State of Illinois
CAPITAL DEVELOPMENT BOARD

SUBJECT: ADDENDUM NO. FIVE TO THE BIDDING DOCUMENTS FOR

CDB-756-030-001
Illinois Treasury Department Relocation
One East Old State Capitol Plaza
Springfield, Illinois 62701

1 LOWER LEVEL PLUMBING RENOVATION PLAN
P2.1.0/SCALE: 1/8"=1'-0"

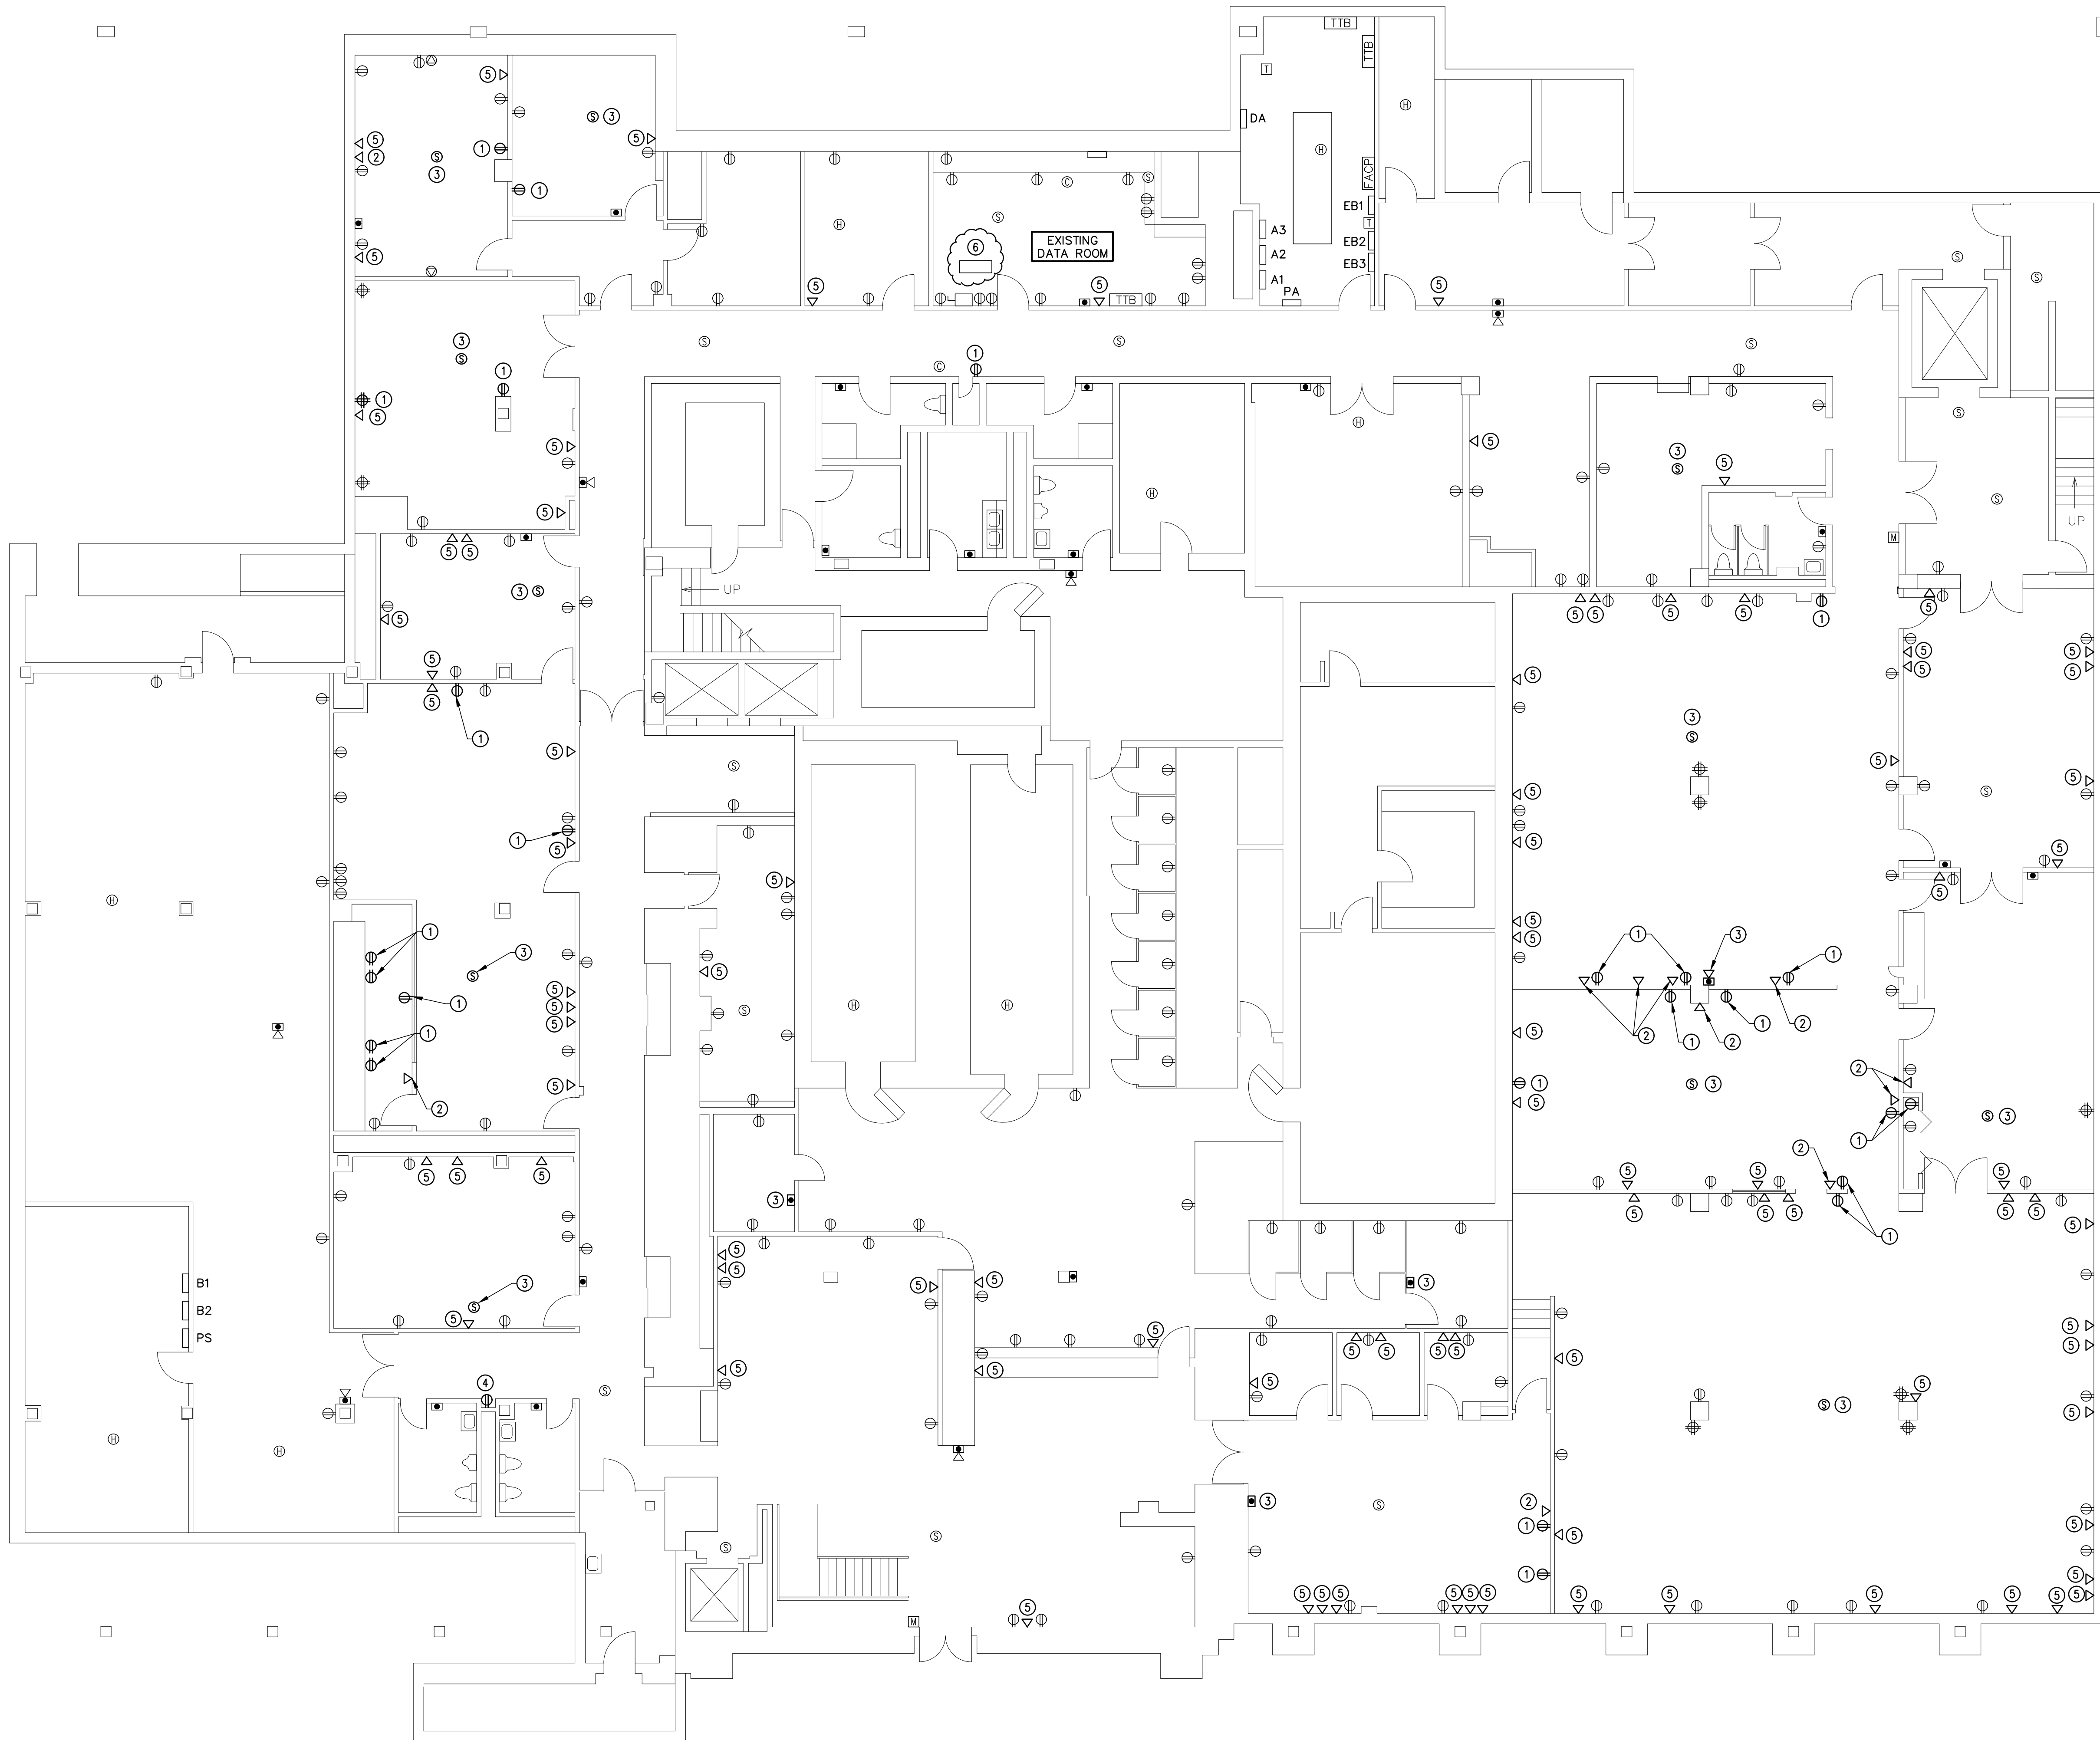
4. SHEET P2.1.0 – “Lower Level Plumbing Renovation Plan”
 - a. Revision #3.
 - b. Utility sink information included for Print Shop #074.
 - c. See attached revised drawing.

1. Questions from Adam Boelman with Jones-Blythe Construction Company:
 - a. Drawing A2.1.0 Note C6 calls for a new mop sink in room 074 Print Shop. There is not plumbing shown to this new mop sink on drawings P2.1.0. Please advise if this mop sink is required.

- i. *There will be a new utility sink in Print Room 074 at the location of an existing electric water cooler that will be removed.*
 - b. Drawing A2.1.3 Note C9 calls for replacing the fireproofing, Can you provide approximate square footage for this work?

16. EXISTING WATER COOLER TO BE REMOVED. EXISTING DOMESTIC COLD AND SANITARY PIPING TO REMAIN. PROVIDE NEW 23"X25" LAUNDRY TUB (EL MUSTEE CP14, FIAT P1, OR ZURN MS2620) WITH 6" SWING ADA COMPLIANT FAUCET. PROVIDE/MODIFY DOMESTIC COLD AND SANITARY PIPING TO CONNECT TUB TO EXISTING PIPING. PROVIDE 1/2" DOMESTIC HOT WATER PIPING TO CONNECT TO EXISTING HOT WATER PIPING IN PLUMBING CHASE. PROVIDE 1/4 TURN SHUT OFF VALVES AND STAINLESS STEEL BRAIDED HOSES TO CONNECT FAUCET TO DOMESTIC PIPING.
